# PSEGLI Hosting Capacity General Review Initiative

*Summary & Comments on Historic Initiatives, &  
Questions Regarding Substation Backfeeding*

*Version 3c*

#### Sample Substation ID - 6915 Information:

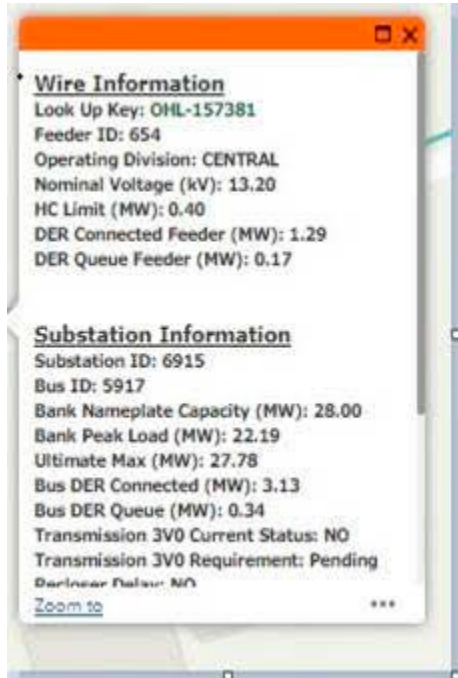
Industry is having difficulty understanding how the Ultimate Max HC is calculated. Following is a sample analysis using the screenshot data by industry. We would appreciate additional guidance or corrections on our analysis below.

- Industry acknowledges what this value does not capture the items above
- Observe that the sum of connected + queued DER = 3.47MW.
- Thus minimum daytime load (according to ITR) = Peak load x 0.5 = 11.095MW
- Minimum Load (according to ITR) = Peak load x 0.3 = 6.657 MW
- Based on assumptions and simple calculation Ultimate Max HC on the substation can be calculated as (Bank Nameplate Rating - (Connected DER + Queued DER)) = (28 - 3.47) = 24.53MW.

- A. Can PSEGLI share a technical paper by EPRI Drive team, or can PSEGLI share additional technical details on how the "HC Limit" value is determined, beyond the existing summary explanation above?
- B. Can PSEGLI share a technical paper by EPRI Drive team, or can PSEGLI share additional technical details on how the "Ultimate Max" value is determined, beyond the existing summary explanation above?
- C. Are the ITR defined minimum daytime and minimum load considerations applied to HCM?
